Marked-up Revised Response
to NRC RAI No. 02.05.01-21 (eRAI 6024)

The following new references will be included in a future revision of the FSAR:

The following new figures will be added in a future revision of the COLA:

Figure 2.5.1-368. Fault Map of Cuba Showing Earthquakes from the Project Phase 2 Earthquake Catalog (Sheet 1 of 3)

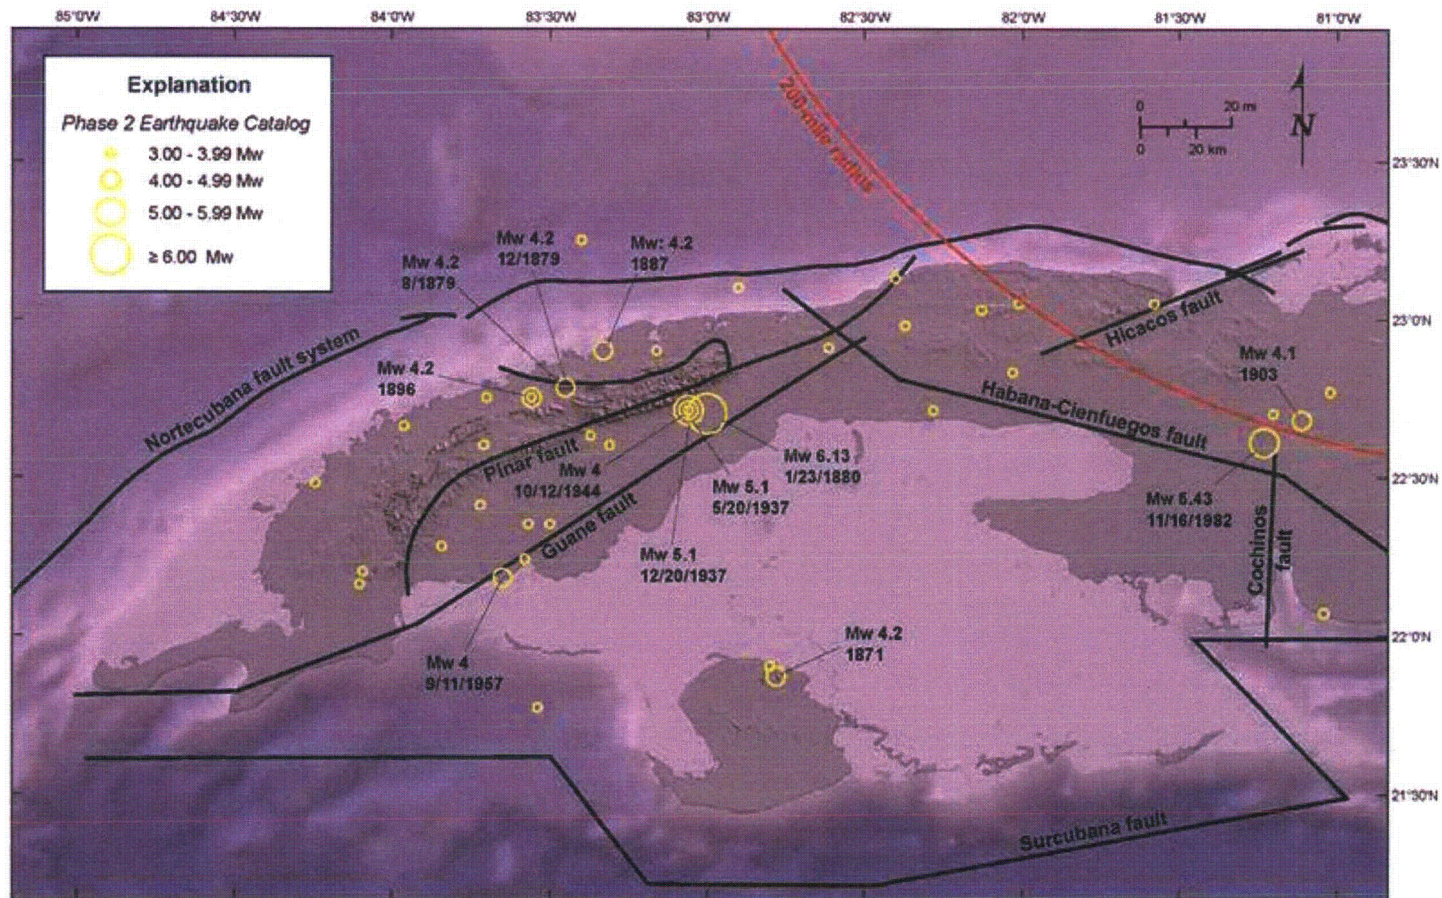
The Pinar fault is a northeast-striking, steeply southeast-dipping fault in western Cuba (Figures 2.5.1-247, 2.5.1-251, 2.5.1-289, and 2.5.1-368 Sheet 1). As mapped by Tait (Reference 448) and shown on Figure 2.5.1-368 Sheet 1, the Pinar fault is located, at its nearest point, approximately 330 kilometers (205 miles) ~~205 miles (330 km)~~ from the Turkey Point Units 6 & 7 site. As mapped by Garcia et al. (Reference 489), the Pinar fault is approximately 320 kilometers (200 miles) ~~200 miles (320 km)~~ southwest of the site at its nearest point. As mapped by Cotilla-Rodríguez et al. (Reference 494), the Pinar fault is approximately 360 kilometers (225 miles) ~~225 miles (360 km)~~ southwest of the site at its nearest point. Rosencrantz (Reference 529) maps a series of offshore faults along the eastern Yucatan Platform and tentatively indicates they could be the offshore southwestern extension of the Pinar fault.

The Phase 2 earthquake catalog indicates that a M_w 6.13 earthquake occurred on January 23, 1880 in western Cuba in the vicinity of the Pinar and Guane faults (Figure 2.5.1-368 Sheet 1). The epicenter of this poorly located, pre-instrumental earthquake is approximately 11 kilometers (7 miles) ~~7 miles (11 km)~~ south of the trace of the steeply southeast-dipping Pinar fault and approximately 8 kilometers (5 miles) ~~5 miles (8 km)~~ north of the Guane fault. As Garcia et al. (Reference 489) suggest, however, locational uncertainties for historical earthquakes in Cuba could be on the order of 15 to 20 kilometers (9 to 12 miles) or more. Based on available information, it is not possible to definitively state whether the 1880 earthquake occurred on the Guane fault, the Pinar fault, or another fault in the region. No focal mechanism or depth determination for the 1880 earthquake is available with which to help identify the causative fault. Moreover, no paleoseismic trench studies or detailed tectonic geomorphic assessments are available for the Pinar fault, Guane fault, or other faults in the region. The Phase 2 earthquake catalog indicates generally sparse seismicity in the vicinity of the Pinar fault (Figure 2.5.1-368 Sheet 1). There does not appear to be an alignment of epicenters along the Pinar fault, but rather sparse earthquakes appear distributed throughout western Cuba both north and south of the fault in the Sierra del Rosario mountains and the Palacios Basin. The Phase 2 earthquake catalog indicates that additional minor- to moderate-magnitude (M_w 4 to 5.1) earthquakes occurred in western Cuba near the Pinar and Guane faults in 1896, 1937, 1944, and 1957 (Figure 2.5.1-368 Sheet 1).

Figure 2.5.1-368. Fault Map of Cuba Showing Earthquakes from the Project Phase 2 Earthquake Catalog (Sheet 2 of 3)

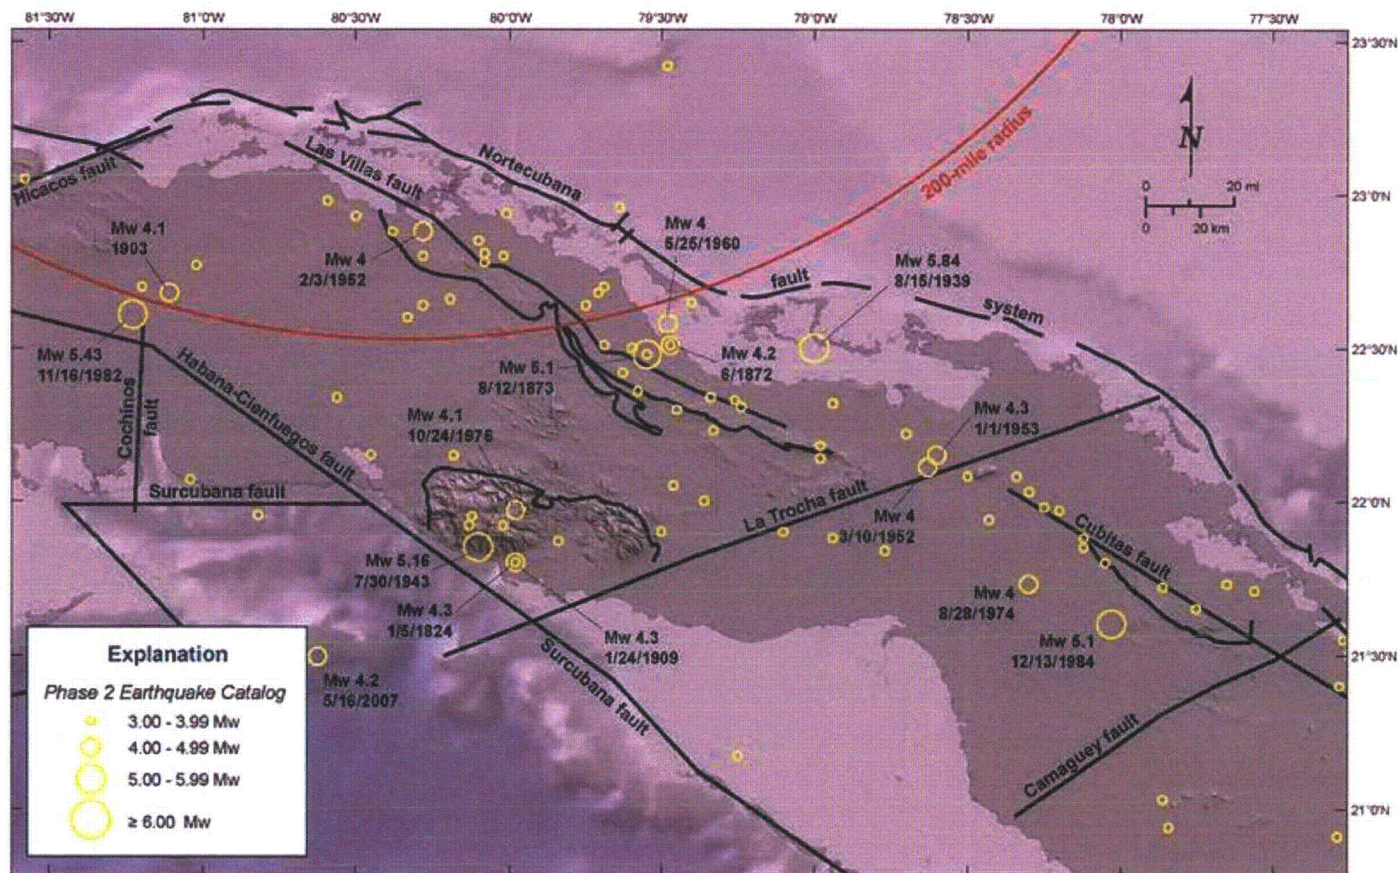
Figure 2.5.1-368 Sheet 2 indicates moderately sparse seismicity from the Phase 2 earthquake catalog that may be roughly aligned with the Las Villas fault, as mapped by Pardo (Reference 439). A total of 33 earthquakes from the Phase 2 earthquake catalog are located within approximately 10 kilometers (6 miles) ~~6 miles (10 km)~~ of the Las Villas fault along its length. Of these, 29 are located northeast of the trace of this southwest-dipping fault, with the remaining four located southwest of the fault trace. The largest earthquake near the Las Villas fault is the August 12, 1873 M_w 5.1 earthquake, located approximately 5 kilometers (3 miles) ~~3 miles (5 km)~~ northeast of the fault (Figure 2.5.1-368 Sheet 2). Cotilla-Rodríguez et al. (Reference 494) indicate focal mechanisms for these earthquakes are unavailable, so it is not possible to assess whether these possibly roughly aligned epicenters occurred on the Las Villas fault or on another fault or faults. Cotilla-Rodríguez et al. (Reference 494) suggest that the largest recorded earthquake associated with the Las Villas fault is the M_s 5.6 event on August 15, 1939 (listed in the Phase 2 earthquake as M_w 5.84). Based on the fault mapping of Pardo (Reference 439) and the location of this earthquake from the Phase 2 earthquake catalog, however, this earthquake is located approximately 32 kilometers (20 miles) ~~20 miles (32 km)~~ northeast of this southwest-dipping fault (Figure 2.5.1-368 Sheet 2), suggesting a fault other than the Las Villas ruptured during this event.

Figure 2.5.1-368. Fault Map of Cuba Showing Earthquakes from the Project Phase 2 Earthquake Catalog (Sheet 3 of 3)

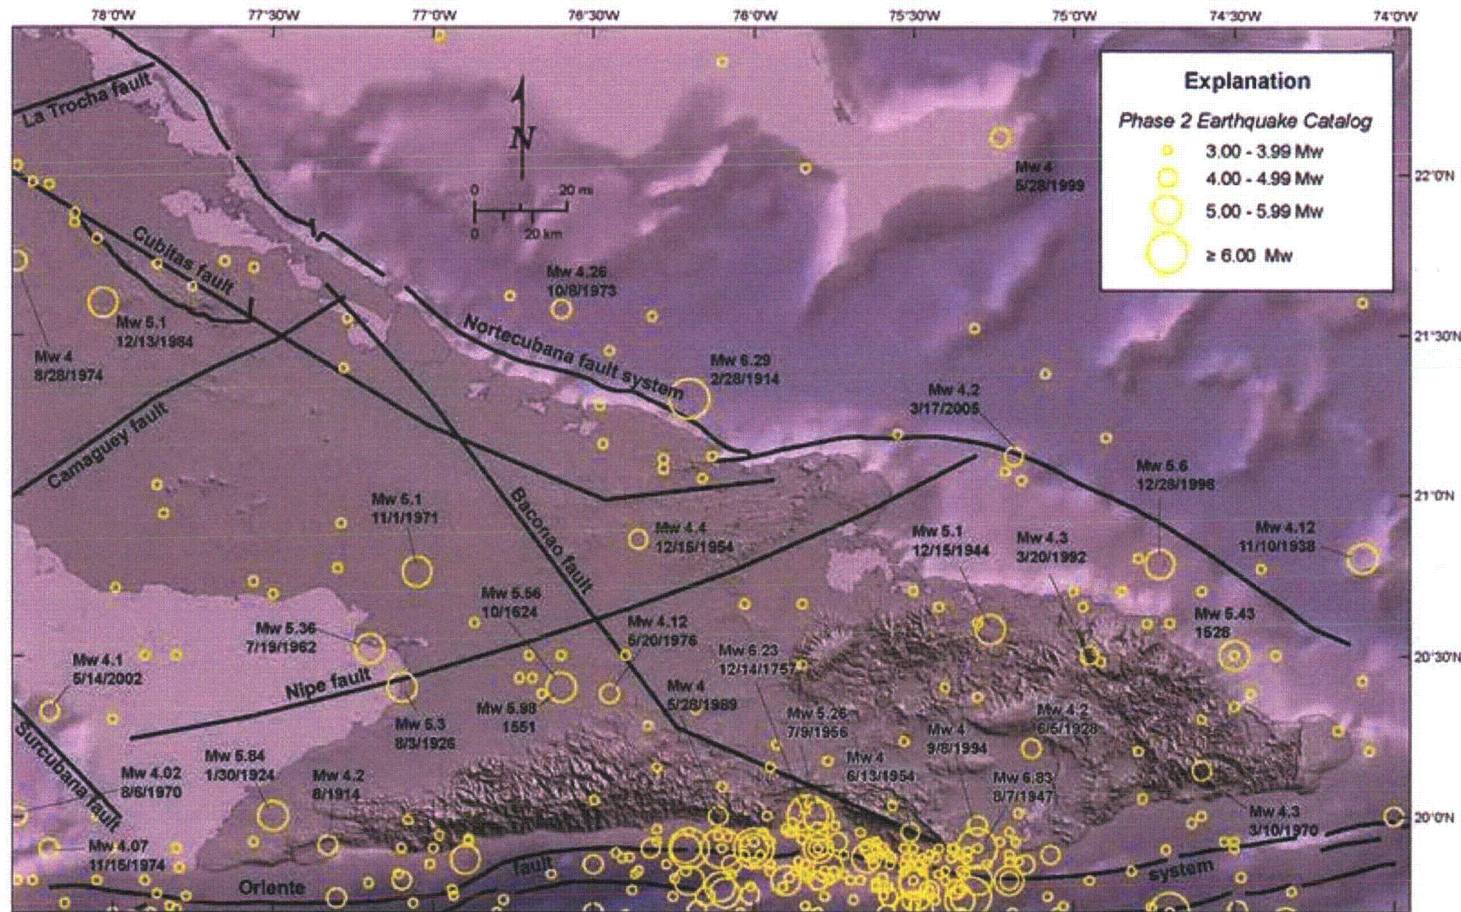
The Nipe fault is a northeast-striking fault in southern Cuba (Figures 2.5.1-247 and 2.5.1-368 Sheet 3) that separates the mountainous Sierra Maestra province on the east from the Camaguey terrane on the west. At its nearest point, the Nipe fault is approximately 675 kilometers (420 miles) ~~420 miles (675 km)~~ from the Turkey Point Units 6 & 7 site. Other names for this fault include the Cauto, Cauto-Nipe, Guacanayabo, and Nipe- Guacanayabo fault.

The most seismically active region of Cuba today is the Oriente fault zone, located offshore south of eastern Cuba (Figures 2.5.1-229, 2.5.1-247, 2.5.1-251, and 2.5.1-368 Sheet 3). This left-lateral fault system is part of the active North America-Caribbean Plate boundary and connects the Cayman Trough spreading center to the Septentrional fault (Figure 2.5.1-202). Geodetic data indicate that between 8 and 13 millimeters/year of slip are accommodated on this structure; hence it is classified as a capable tectonic source. For further discussion, see Subsections 2.5.1.1.2.3.1.2, 2.5.2.4.4.3.2.2, and 2.5.2.4.4.3.2.3.

Figure 2.5.1-279 Offshore Cross Section across the Cuban Fold-and-Thrust Belt, Western Cuba

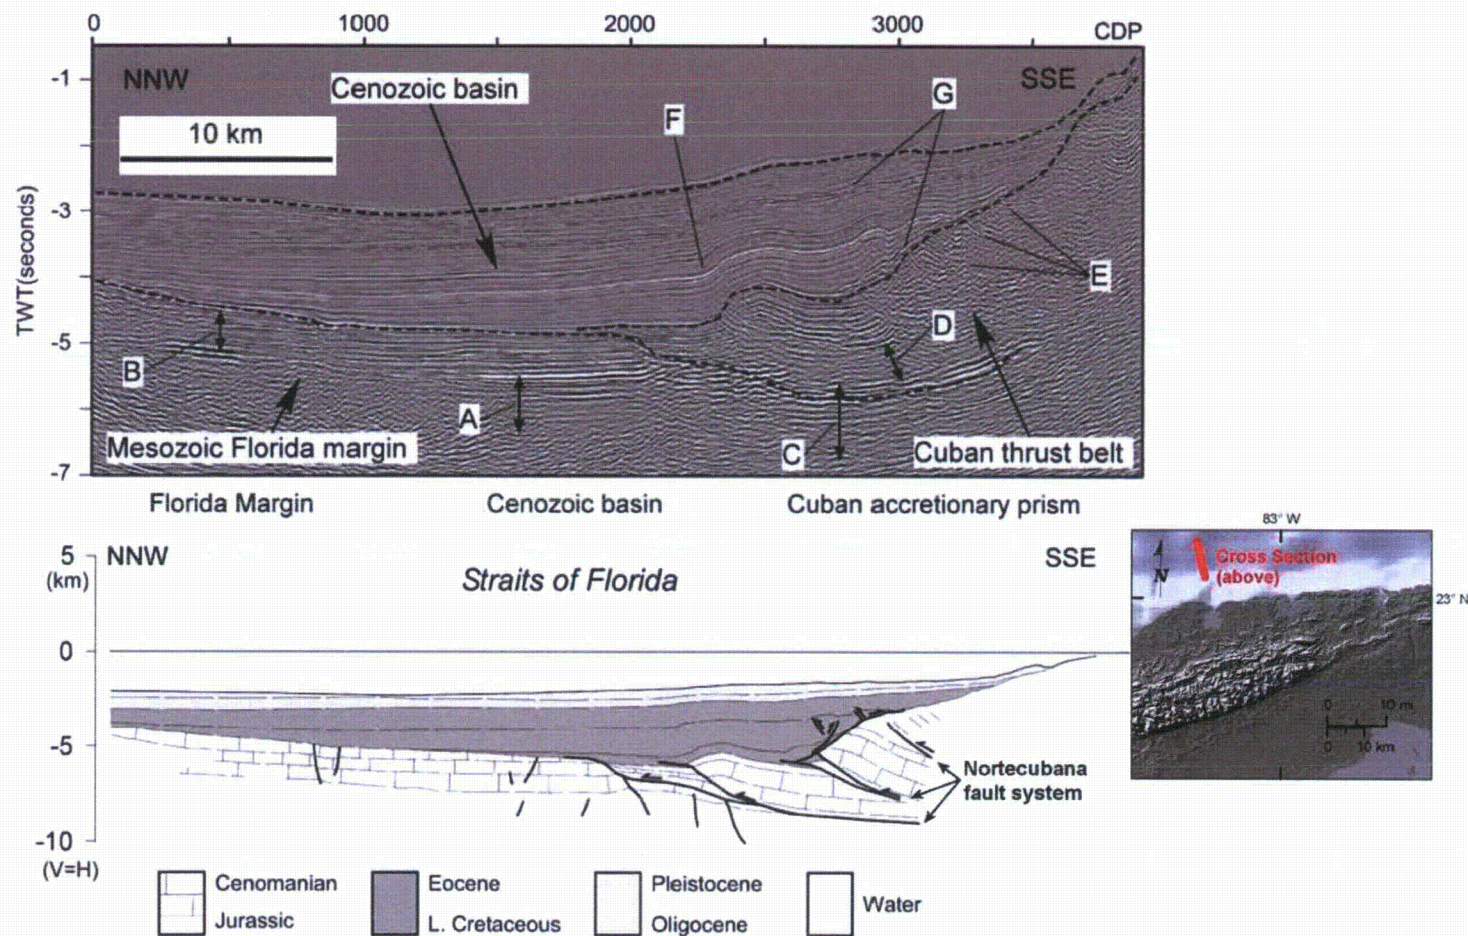
FSAR Figure 2.5.1-279 will be replaced with the revised figure shown below in a future revision of the FSAR.
